PSNN-2014-0869

Group(担当部門名):	Second Electrical	System Design &
	Engineering Gr.	
Approved by (承認)	Reviewed by (調査)	Prepared by (作成)
N. Oda	N. Oda	T. Hayashi
Sept. 28, 2017	Sept. 28, 2017	Sept. 28, 2017

Job No.	DCN No.	Rev. No.	Doc. Title. No. and Rev. No.	1 1 / 22
FPG	DCN-FPG-TRT-C51-0101-002	0	Qualification Test Summary Report, FPG-TRT-C51-0101 Rev.2	sh- 1 / 33

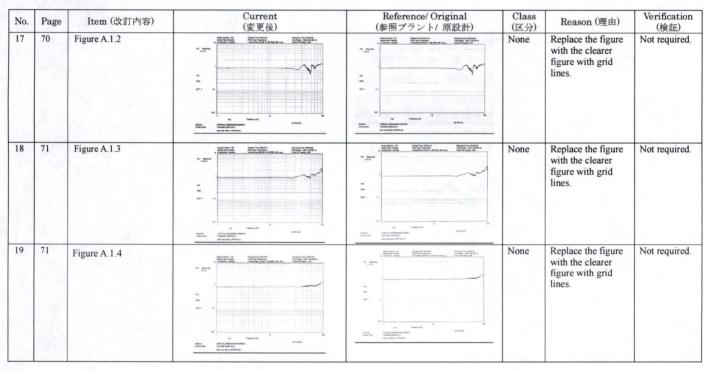
response during the seismic tests show that no filtering of test input occurred below the test facility standard practice 100 Hz frequency limit.  Thus. Toshiba evaluates the Test Specimen Units and the power line panel do not show major resonance.				
11	50-52	6.3.2.Data Evaluation (2)Random Multifrequency Tests (5 OBEs and 1 SSE)	Figures in sections A.2.1 to A.2.5 show the TRS for OBE tests and Figures in Section A2.6 show Test Response Spectra for the SSE test. Figures A2.6.4 to A2.6.6 show the coherent plot of the SSE.  Toshiba planned to conduct the seismic test with the RRS provided in Figure 4.5 of EPRI TR:107330 dated October 1997. The TRS listed in figures in Appendix A.2 of the Qualification Test Summarv Report were achievable. Toshiba considers that exceedances below about 3.5 Hz are generally acceptable based on IEEE Std. 344 2004 Section 8.6.3.1(p) since there are clearly no resonances below 5 Hz. Toshiba evaluated the higher frequency area. Toshiba found that Figure 4.5 of a later version of EPRI TR:107330 is slightly different from Figure 4.5 in the original October 1997 version which is the basis for the current Toshiba RRS. Toshiba evaluated the difference. The later version (available from the EPRI website) provides Figure 4.5 with a narrow peak spectral band. Specifically, the 5% damped SSE response	Figures in sections A.2.1 to A.2.5 show the TRS for OBE tests and Figures in Section A2.6 show Test Response Spectra for the SSE test. Figures A2.6.4 to A2.6.6 show the coherent plot of the SSE.  These test results show that the random multi frequency tests conditions were successfully applied to the Test Specimen Units with the single exception of not meeting the peak loading for the SSE, based on table limits.	Ш	Detailed descriptions and a figure are added.	See DVR-E2-201 70928.

No.	Page	Item (改訂内容)	Current (変更後)	Reference/ Original (参照プラント/ 原設計)	Class (区分)	Reason (理由)	Verification (検証)
			spectrum control points of Figure 4-5 of the later version of EPRI TR-107330 are (1 Hz. 0.42 g): (4.5 Hz. 14 g): (16 Hz. 14 g): (33 Hz.6.13 g). and (100 Hz. 6.13 g). The original version of Figure 4-5 includes a broader frequency. Specifically. the 5 % damped SSE response spectrum break points of this version of Figure 4-5 are (0.5 Hz. 0.1 g): (1 Hz. 0.8 g): (3 Hz. 14 g): (33 Hz. 14 g): (40 Hz. 7 g): and (100 Hz. 7 g). The discussion here refers to the version of EPRI TR-107330 Figure 4-5 of the later version of EPRI TR-107330 as the "narrow" spectrum. and the other version of EPRI TR-107330 Figure 4-5 as the "broad"				
		Continued	spectrum.  Because of test table limitation of 9.8 g. Toshiba has had to take exception to the EPRI TR-107330 requirement of 14 g in the PRM testing. The PRM testing was conducted at a			Continued

laboratory where the table could not satisfy the EPRI TR-107330 peak spectral limits. Specifically, the table could only satisfy a peak spectral demand of 9.8 g. PRM test results show that the "narrow" spectrum demand is satisfied with the following exceptions.  The 14 g peak in the narrow spectrum was above the table capacity. The table capacity produced a peak that exceeded 9.8 g.  Exceedances in the frequency lower than 3.5 Hz are acceptable based on Clause 8.6.3.1(j) of IEEE Std. 344-2004 since there are clearly no resonances below 5 Hz.  An additional exception to the "broad" EPRI TR-107330 spectrum

No.	Page	Item (改訂内容)	Current (変更後)	Reference/ Original (参照プラント/ 原設計)	Class (区分)	Reason (理由)	Verification (検証)
			demand would have to be taken for the exceedance at the peak above 30 Hz.  Figure 6.3.1 shows the qualified SSE response of the PRM seismic test.				
		Continued				Continued	
			Figure 6.3.1 Qualified SSE for PRM				
12	56	6.4.2.1 EMI/RFI Emission Test	From 100 Hz to approximately 1200 Hz, the emission exceeded the limit shown in RG1.180R1.	From 100 Hz to 700 Hz, the emission exceeded the limit shown in RG1.180R1.	Ш	Data evaluation correction.	See DVR-E2-201 70928.
13	59	6.4.2.3 Surge Withstand Capability Test	'[Line and Neutral] and Ground, only for Ring Wave*  *Note: IEC 61000-4-5 (for Combination Wave) does not require the test for '[Line and Neutral] and Ground." Only Edition 1 (1995) of IEC 61000-4-12 (for Ring Wave) required the test for "[Line and Neutral] and Ground." while later Editions of the same standard do not	·[Line and Neutral] and Ground, only for Ring Wave	Ш	Supplemental descriptions are added	See DVR-E2-201 70928.

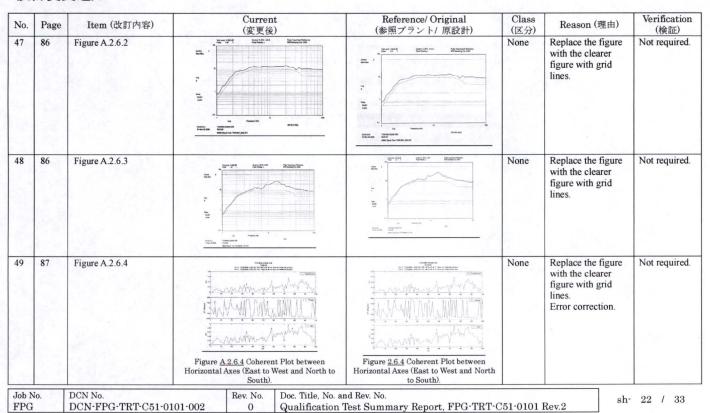
No.	Page	(変更後)		Reference/ Original (参照プラント/ 原設計)	Class (区分)	Reason (理由)	Verification (検証)
50	87	Figure A.2.6.5		M. M	None	Replace the figure with the clearer figure with grid lines.	Not required.
			Figure <u>A.</u> 2.6.5 Coherent Plot for Horizontal Axis (East to West) and Vertical Axis.	Figure 2.6.5 Coherent Plot for Horizontal Axis (East to West) and Vertical Axis.		1.58	
51	88	Figure A.2.6.6			None	Replace the figure with the clearer figure with grid lines.	Not required.
			Figure A.2.6.6 Coherent Plot for Horizontal Axis (North to South) and Vertical Axis.	Figure 2.6.6 Coherent Plot for Horizontal Axis (North to South) and Vertical Axis.

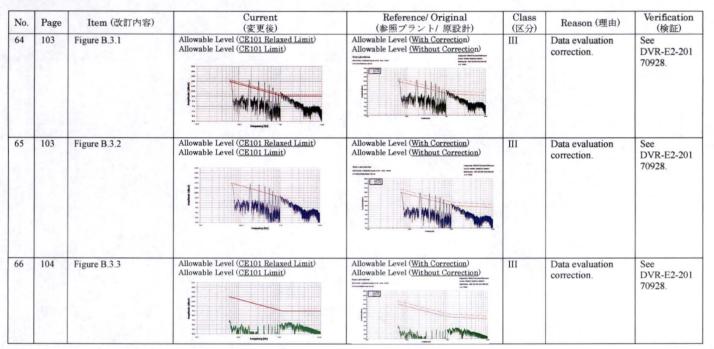
No.	Page	Item (改訂内容)	Current (変更後)	Reference/ Original (参照プラント/ 原設計)	Class (区分)	Reason (理由)	Verification (検証)
67	104	Figure B.3.4	Allowable Level (CE101 Relaxed Limit) Allowable Level (CE101 Limit)	Allowable Level (With Correction) Allowable Level (Without Correction)	Ш	Data evaluation correction.	See DVR-E2-201 70928.
68	105	Figure B.3.5	Allowable Level (CE101 Relaxed Limit) Allowable Level (CE101 Limit)	Allowable Level (With Correction) Allowable Level (Without Correction)	Ш	Data evaluation correction.	See DVR-E2-201 70928.
69	105	Figure B.3.6	Allowable Level (CE101 Relaxed Limit) Allowable Level (CE101 Limit)	Allowable Level (With Correction) Allowable Level (Without Correction)	Ш	Data evaluation correction.	See DVR-E2-201 70928.
